Case Number: R18003

**CASE COMMENTS:**

**Existing Stormwater Asset Map possibly affected by the Proposed Development**

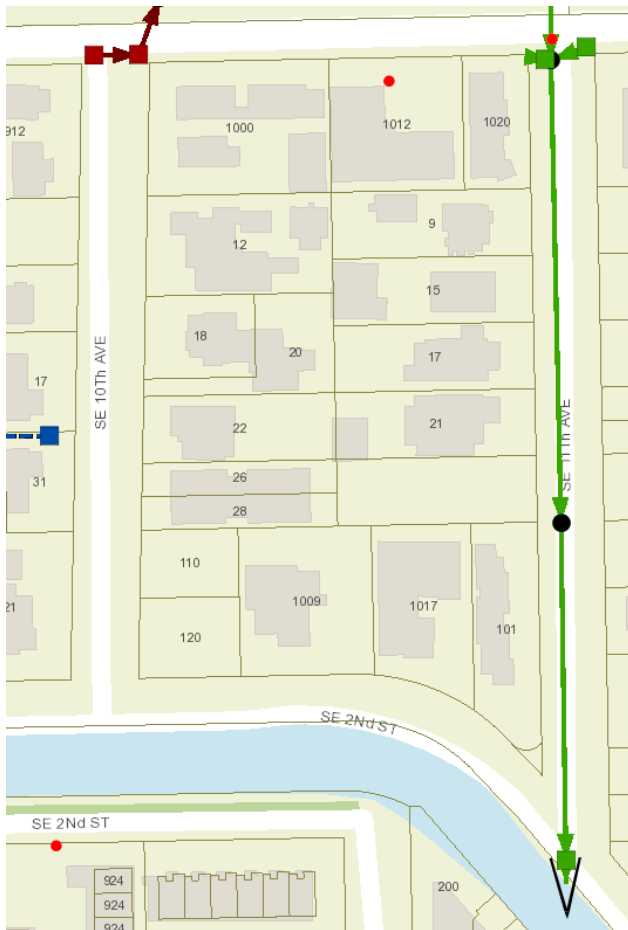
The City owns and maintains stormwater infrastructure adjacent to the proposed development as shown with green line work in the map provided at the end of this report. The following comments pertain to possible impacts of the proposed development and/or construction activities to the existing condition of the City's stormwater assets. The applicant shall provide an itemized response letter addressing the following comments:

1. Please provide (or revise if already submitted) an erosion, sedimentation, and stormwater pollution prevention plan (**SWPPP**) showing the adjacent City's existing stormwater system as shown in the survey and to the limits shown with green line work in the storm map provided at the end of this report. A copy of the approved SWPP shall be at the construction site from the date of demolition initiation to the date of final construction activities.

- a) Contractor shall provide CCTV videotapes to City STW OPS of the existing stormwater system to the limits shown with green line work in the storm map provided at the end of this report in order to document the PRE and POST construction conditions of the City's storm system.
